**R66 SERVICE BULLETIN SB-21A**

**SUBJECT:** Oil Tank Outlet Modification

**ROTORCRAFT AFFECTED:** R66 Helicopters S/N 0003 thru 0789, 0791, 0794, and 0796. Spare G689-1 revision J and prior oil tank assemblies are also affected.

**FIGURE 1**

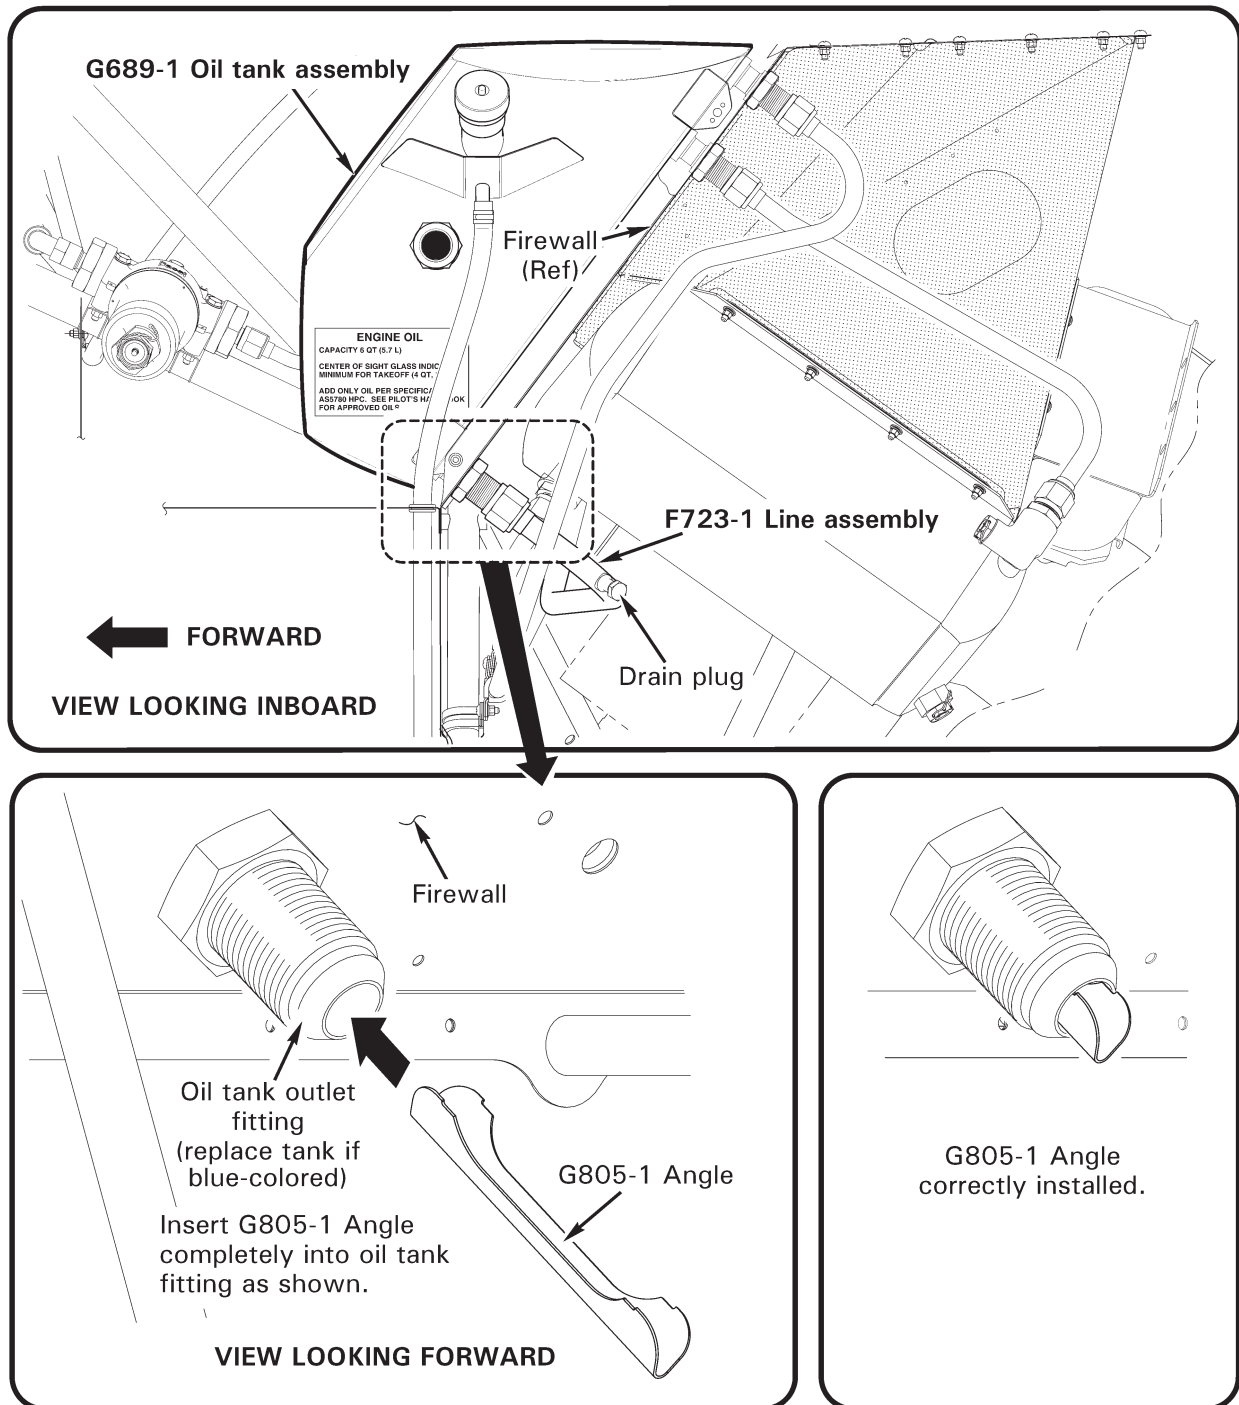
**BACKGROUND:** RHC has received additional reports of a broken oil tank internal baffle. A larger range of helicopters is affected than originally suspected. This bulletin requires installing an angle in the tank outlet that would prevent a failed baffle from blocking the outlet.

1. Refer to Figure 1. Visually inspect oil tank outlet fitting color; if fitting is blue (early revision tanks), tank is not eligible for installation of G805-1 angle and must be replaced. Replacement tanks may still require steps 2 thru 8 depending on revision level.
2. Locate G689-1 oil tank assembly identification ink stamp on top surface of oil tank, and determine revision letter, which immediately follows "G689-1".

3. Drain engine oil per R66 Maintenance Manual (MM) § 12-60. Utilize a suitable clean container if reuse of oil is intended.
4. Refer to Figure 1. Disconnect F723-1 line assembly from tank fitting at firewall.
5. Pinch flanges of G805-1 angle minimum required to enable insertion, and insert angle (clock orientation optional) in oil tank outlet fitting until angle snaps in place.
6. Connect F723-1 line assembly to tank fitting. Special torque nut to 675 in.-lb. Torque stripe fitting per MM Figure 5-1.
7. Add engine oil per MM § 12-60.
8. Make appropriate maintenance record entries. No change to helicopter weight and balance.
